**RE: 13648 Apache Plume Place NE**  
**Grading and Drainage Plan**  
**Engineer's Stamp Date: 10/09/19**  
**Hydrology File: E23D034**

Based upon the information provided in your submittal received 10/21/19, the Revised Grading and Drainage Plan are approved for Building Permit and Building Pad Certification for 13648 Apache Plume Place NE. Please attach a copy of this approved plan in the construction sets for Building Permit processing along with a copy of this letter.

Re: Lot 76 – The Highlands Unit 2 (13648 Apache Plume)  
Review of the Lot Specific Grading and Drainage

ENGINEER'S SEAL  10/9/19 DAVID SOULE P.E. #14522	13648 APACHE PLUME	DRAWN BY: WCUJ
	GRADING AND DRAINAGE PLAN	DATE: 8-12-19
	 1606 CENTRAL AVENUE SE SUITE 201 ALBUQUERQUE, NM 87106 (505) 872-0998	2109064-LAYOUT-8-12-19 SHEET # JOB # 2109064

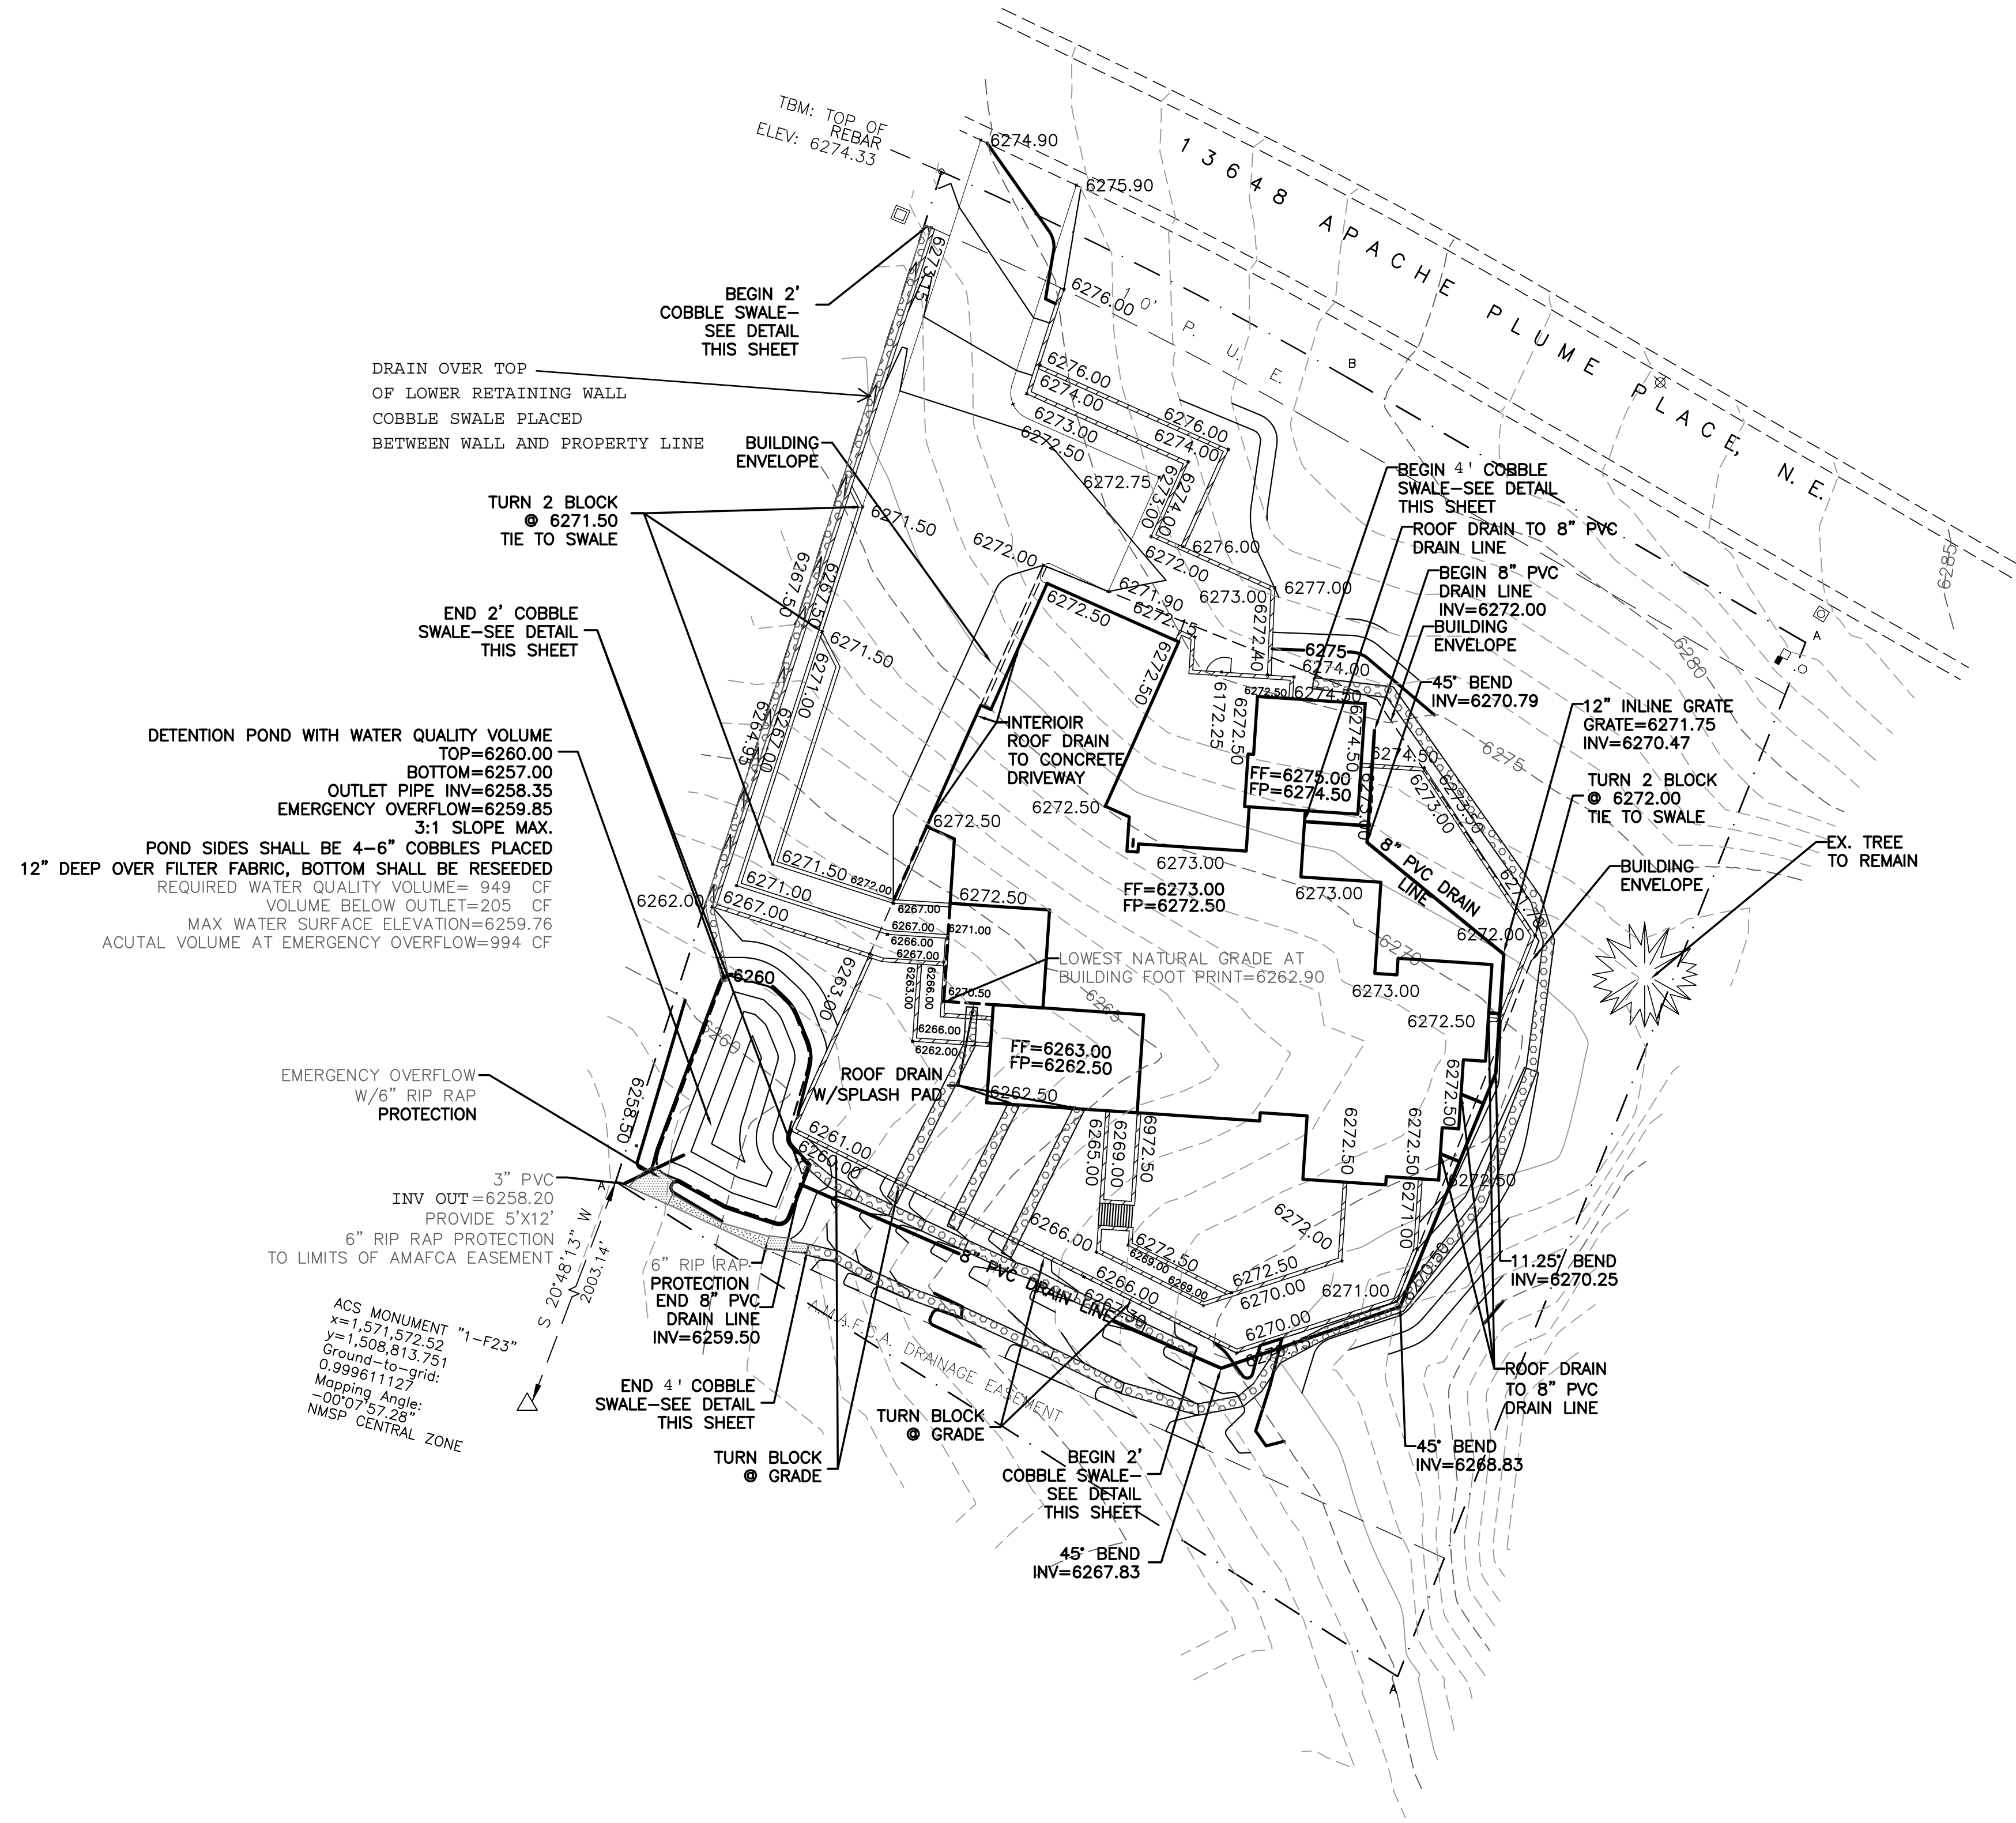
Based on the revised grading and drainage plan for the above referenced Lot stamped dated 10-09-19 by Rio Grande Engineering, it appears that all the comments have been addressed. However, I would request that the swale coming from the north ends at the same location as the outlet pipe from the pond. This change can be asbuilt on the final certification. A copy of the plan is attached.
